DEPARTMENT OF MECHANICAL ENGINEERING  
THE UNIVERSITY OF TEXAS AT AUSTIN

Subject: Emergency Plan  
Quality Assurance Plan

All questions 2a, b, c, d, and e have been corrected in the November 1990 revision of the Quality Assurance Plan (Docket 50-602). Since these questions were editorial or clarification corrections the plan revision number Q was not changed. However, to clarify the corrections from the previous version of the same date the words "Revision Ø" were added to each page. Actual changes were made only on pages 4, 5, 6, 8, 10 and 11 as shown on the enclosure. The enclosure includes a correction copy with annotations and 2 copies of the final plan, Revision Ø, November 1990.

Docket No. 50-602

FIRST LEVEL FLOOR PLAN

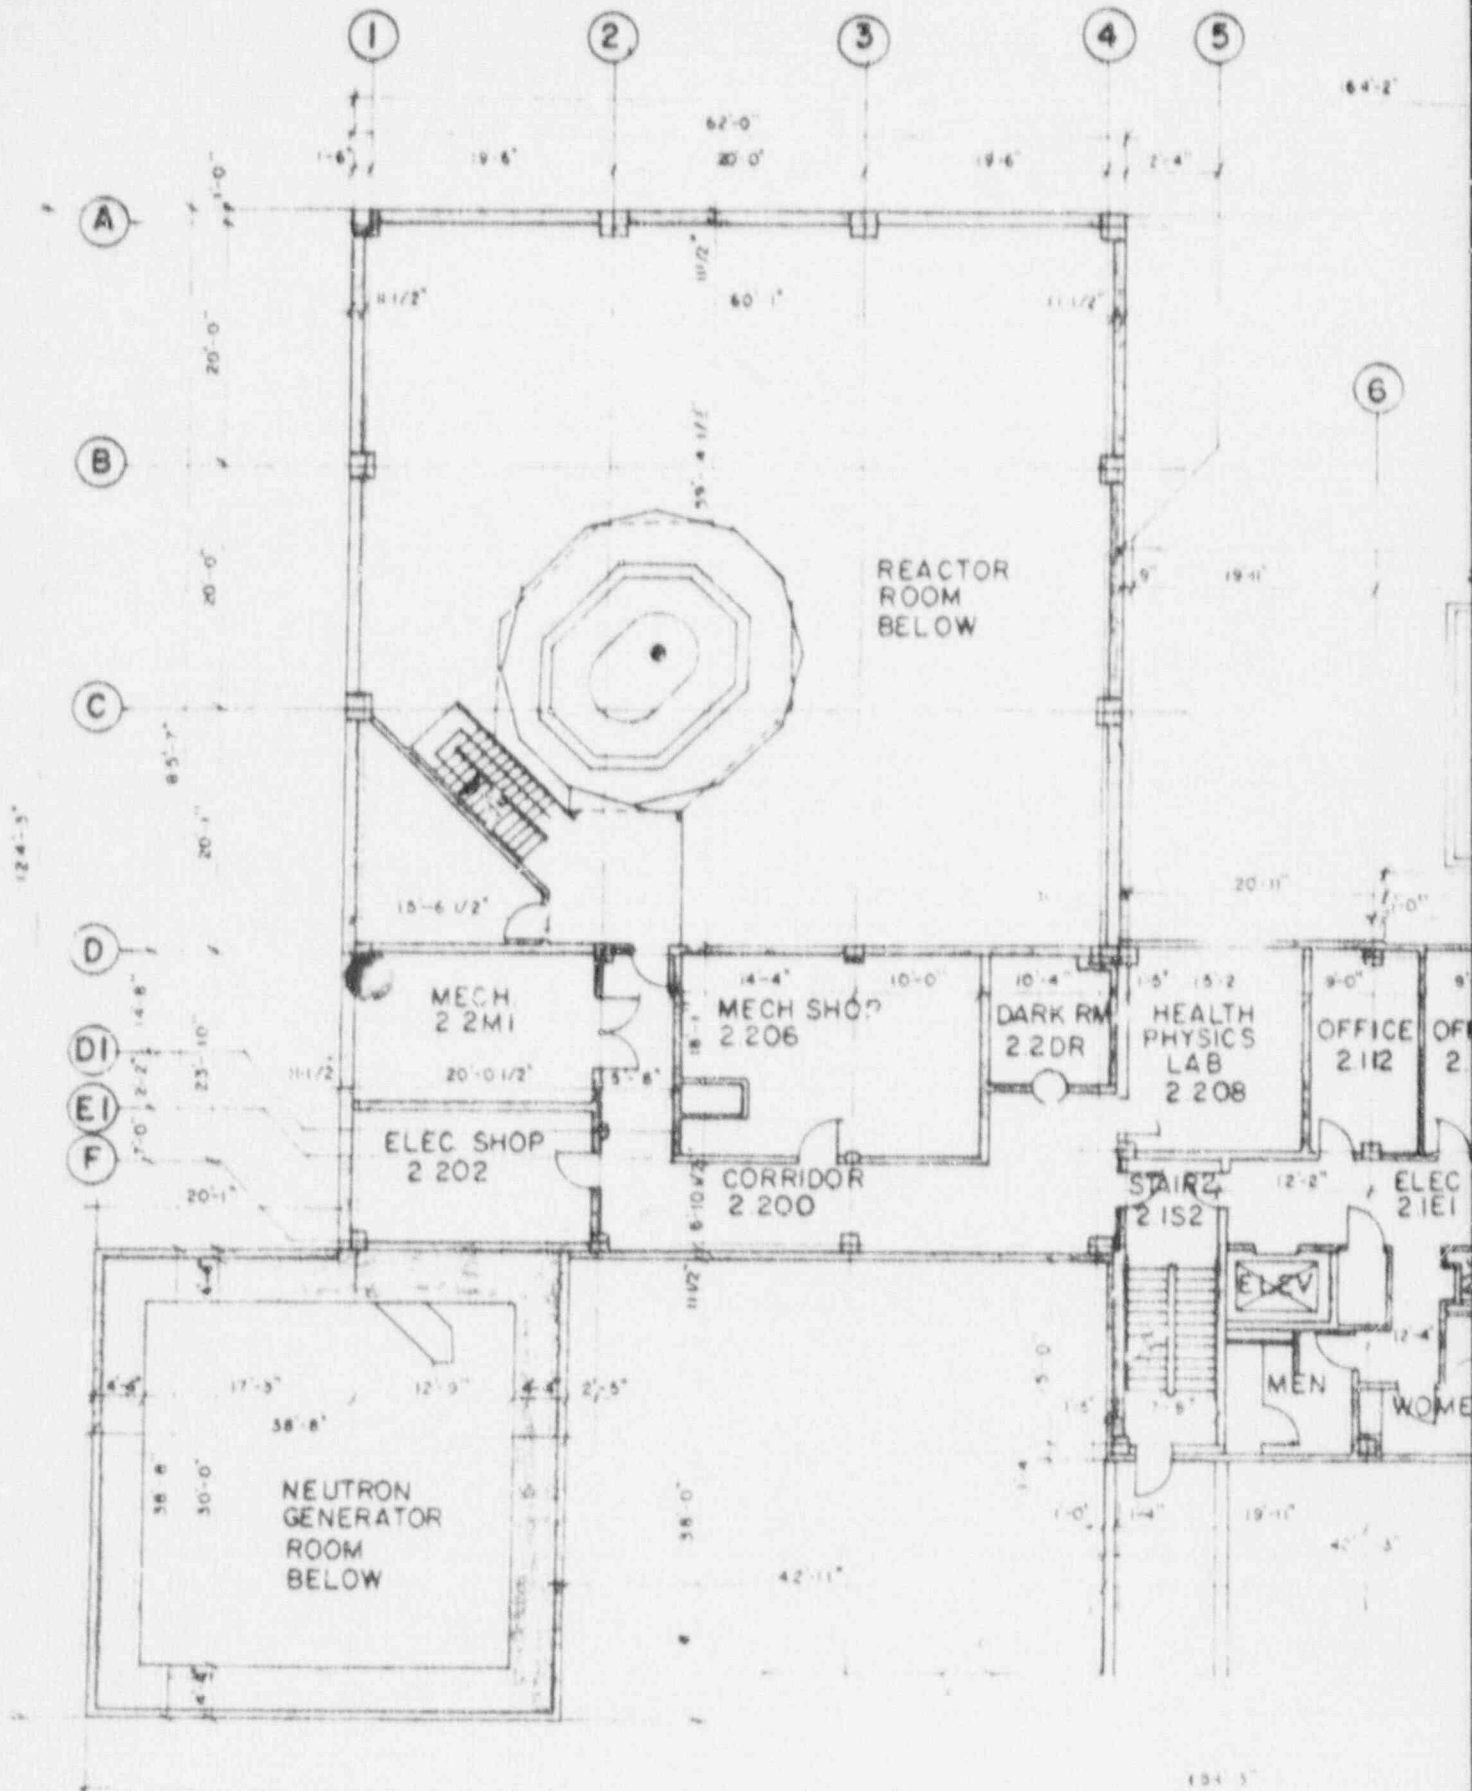
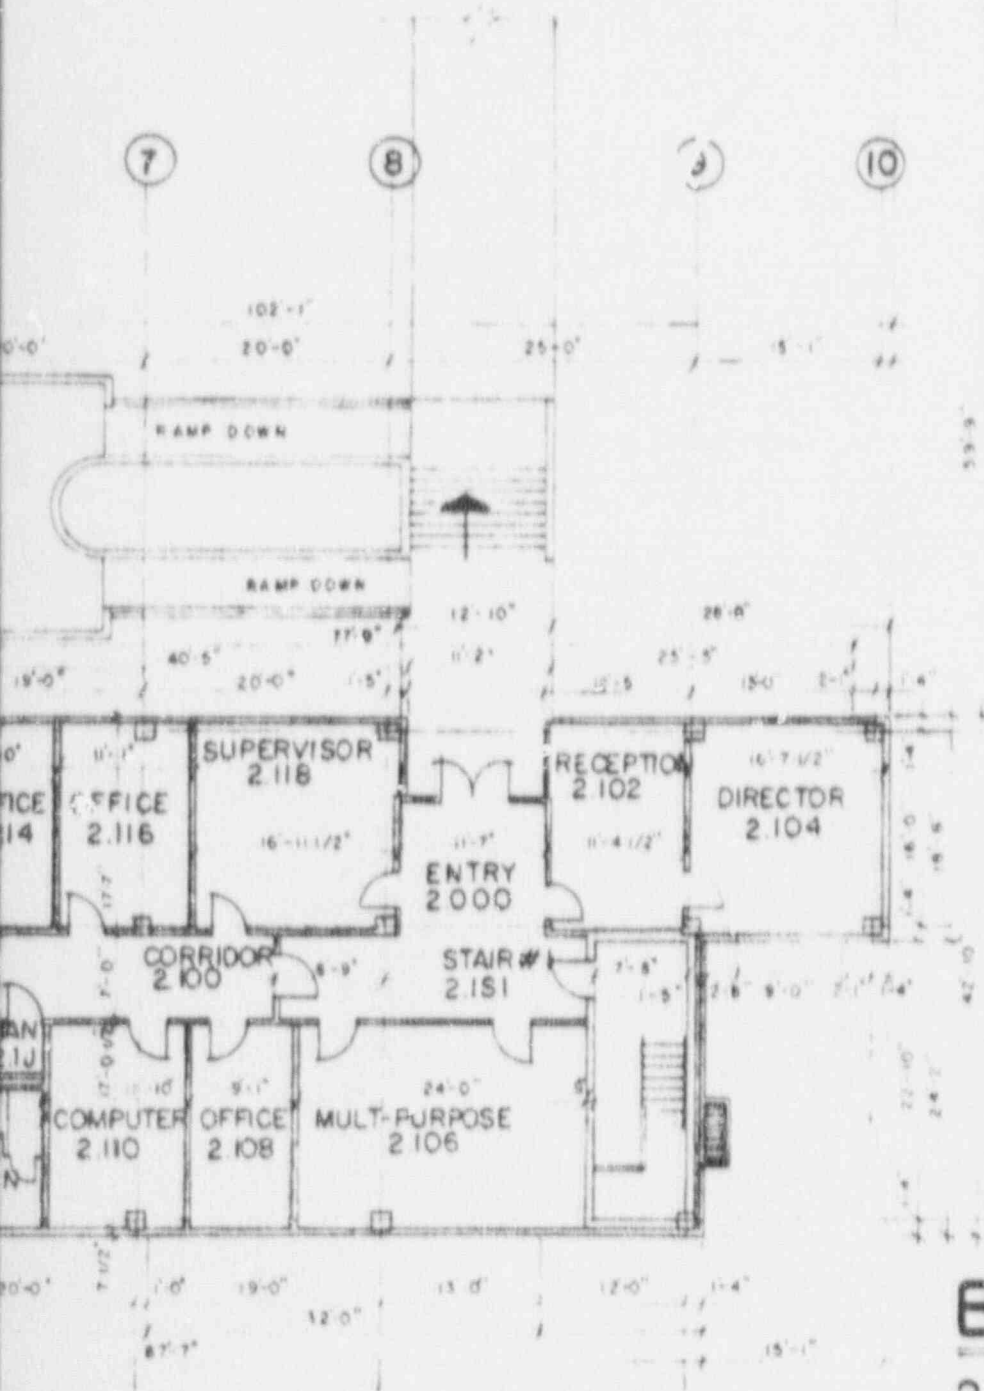
1.c - A set of full size drawings have been provided as appendixes to the plan. These drawings are:

- (1) City of Austin
- (2) Balcones Research Center
- (3) NETL floor plan level 1
- (4) NETL floor plan level 2
- (5) NETL floor plan level 3
- (6) NETL floor plan level 4
